Customer : CU-DAR001 Dart Helicopters Services
Job Number : 42588
Estimate Number : 10973
P.O. Number :
This Issue : 14/10/2008 S.O. No. :
Prsht Rev. : NC
First Issue :
Previous Run : 42587
Written By :
Checked & Approved By :
Drawing Name : 206L AFT X-TUBE
Part Number : D206667203BL
Drawing Number : D206-667-243 REV B
Project Number : N/A
Drawing Revision :
Material :
Due Date : 04/11/2008 Qty: 1 Um: Each

DESIGN PH	DRAWN BY PH	DART AEROSPACE LTD HAWKESBURY, ONTARIO, CANADA	
CHECKED # DS	APPROVED # DS	DRAWING NO. D206-667-243	REV. B SHEET 1 OF 3
DATE 05.07.26		TITLE CROSSTUBE ASS'Y (206L HIGH AFT)	SCALE NTS
A	00.11.17	NEW ISSUE	
B	05.07.26	ADD HOLES AND NUT PLATES FOR COMPATABILITY WITH BHT/AA SKIDTUBES

DART SERVICE INSTRUCTION
TO AMEND INSTALLATION INSTRUCTIONS IIN-D206-667 REV. C AND
INSTRUCTIONS FOR CONTINUED AIRWORTHINESS ICA-D206-667 REV. 2
REF: CANADIAN STC: SH01-5
REF: FAA STC: SR01304NY

FIGURE 1 - CROSSTUBE SUPPORT

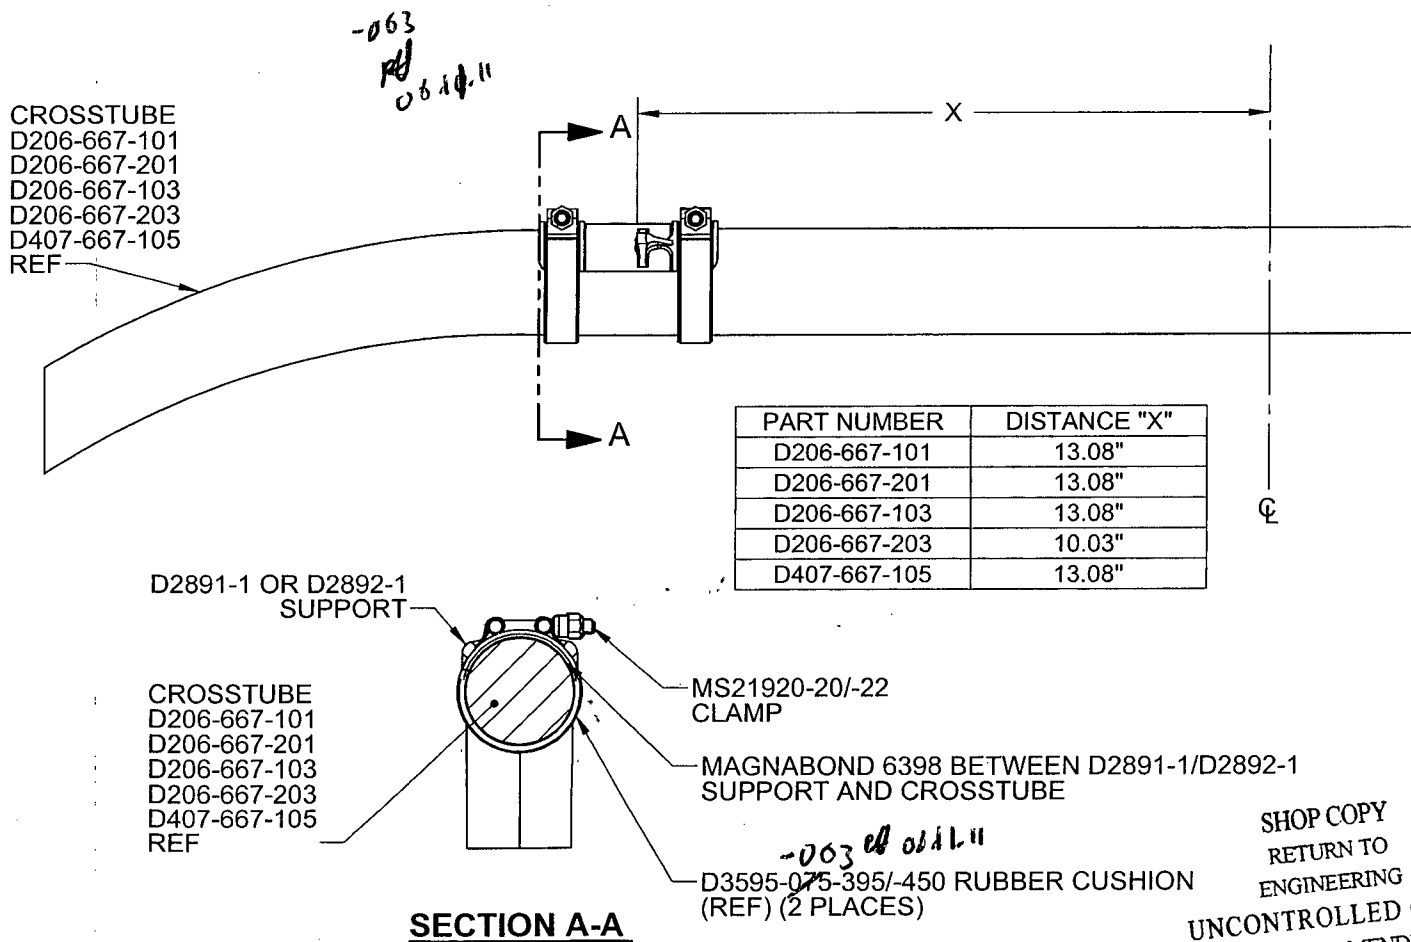
For D206-667-101/-201/-103/-203 or D407-667-105 cross tubes at CHG 003 or later, the D2856-400-694/-773 42516 abrasion strip has been removed, the center D2891-1 or D2892-1 support has been bonded onto the crosstube using Magnabond 6398 and D3595-075-395/-450 Rubber Cushions have been installed underneath the MS21920-20/-22 Clamps. Amend parts list of the IIN-D206-667 section 5 and ICA-D206-667 Section 32.8 as follows:

To prevent the supports from shifting on the D206-667-101/-201/-103/-203 or D407-667-105 crosstubes at CHG 002 or earlier, the D2891-1/D2892-1 supports should be removed and re-installed as follows:

- 6) Apply a 0.03" to 0.06" thick layer of Magnabond 6398 underneath the D2891-1/D2892-1 support and re-install the support on the crosstube as shown in Figure 1. Position and secure the D2891-1/D2892-1 support on the crosstube using MS21920-20/-22 Clamps. Install a D3595-075-395/-450 Rubber cushion underneath each MS21920-20/-22 Clamp. Torque clamps 80-100 in-lb. Let the D206-667-101/-201/-103/-203 or D412-667-105 crosstube assembly cure as per the Magnabond 6398 instructions before re-installing the crosstube on the aircraft.

ITEM	QTY -101	QTY -201	QTY -103	QTY -203	QTY -105	PART NUMBER	DESCRIPTION
13	2	2	2		2	D2856-400-694	ABRASION STRIP
14				2		D2856-400-773	ABRASION STRIP

ITEM	QTY -101	QTY -201	QTY -103	QTY -203	QTY -105	PART NUMBER	DESCRIPTION
24	4	4	4		4	D3595-075-395	RUBBER CUSHION
25				4		D3595-075-450	RUBBER CUSHION
